**THE
NATIONAL
BOARD**
OF BOILER AND
PRESSURE VESSEL
INSPECTORS

NATIONAL BOARD INSPECTION CODE COMMITTEE

AGENDA

Meeting of January 14th, 2021
San Antonio, TX

FIGURE S2.10.2.3

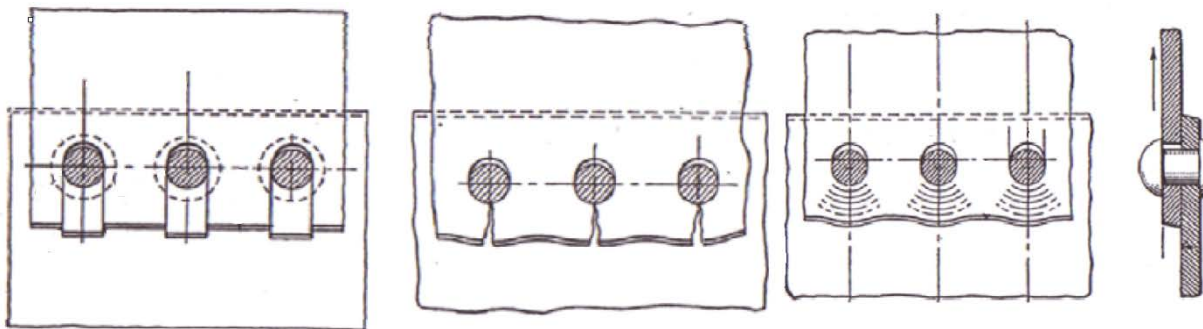
Figure S2.10.2.3 illustrates visual indicators of (c), (d), (e). Inspection shall visually inspect for cracked or stressed plate material along a riveted joint. Indications of failure shall be monitored or repaired, at the discretion of the jurisdiction.

Note: Good engineering practice requires that the lap of plate outside rivet holes, measured from the outer edge of the rivet holes to the edge of the plate must be at least equal to the diameter of the rivet hole.

FIGURE S1.2.11.5-c1
NEW PATCH ALIGNMENT WITH ORIGINAL MATERIAL

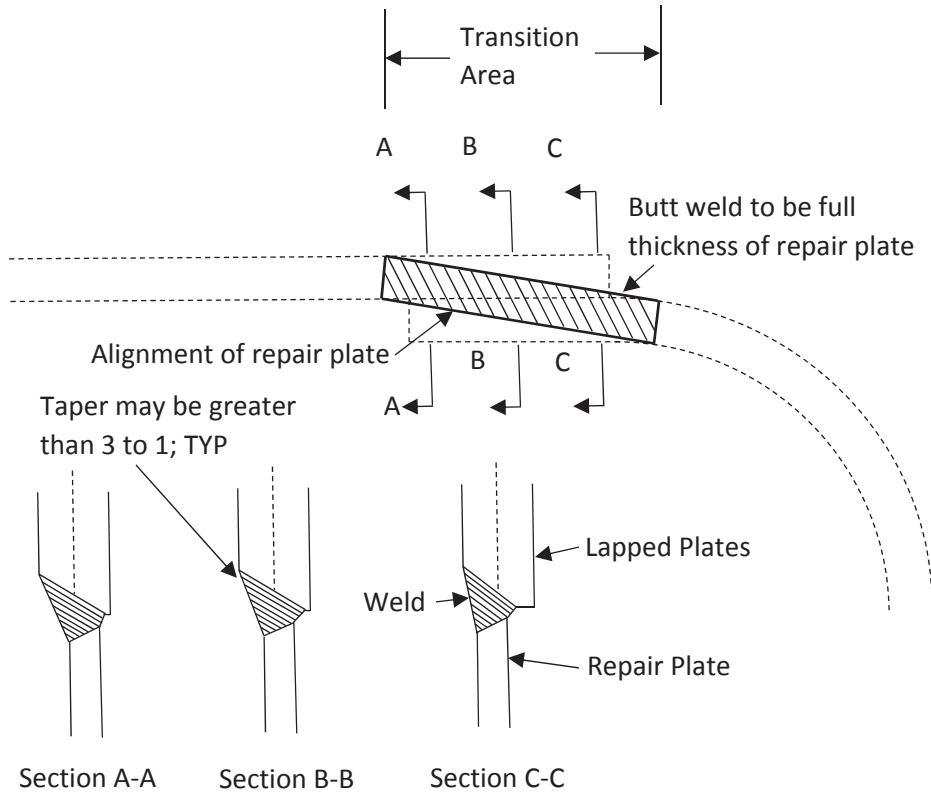
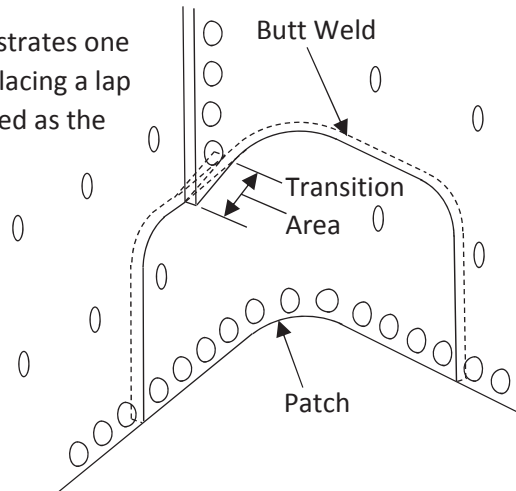
Add a sentence in S1.2.11.5 i); Replace drawing in Figure S1.2.11.5-c1 with new drawing below.

i) For one-piece flange knuckle joint patches in portions of a riveted lap joint or in mud ring corners with a lap joint in the firebox, the knuckle patch shall be supported on at least one of the two planes adjacent to the flange, by means other than the weld. See Figure S1.2.11.5-c1. The weld shall be at least the full thickness of the new plate being installed. Taper of weld in transition area may be greater than 3 to 1. Volumetric examination is not required. This type of repair shall be considered a repair.

This isometric view illustrates one instance of a patch replacing a lap seam and is not intended as the only location where this geometry may be used.
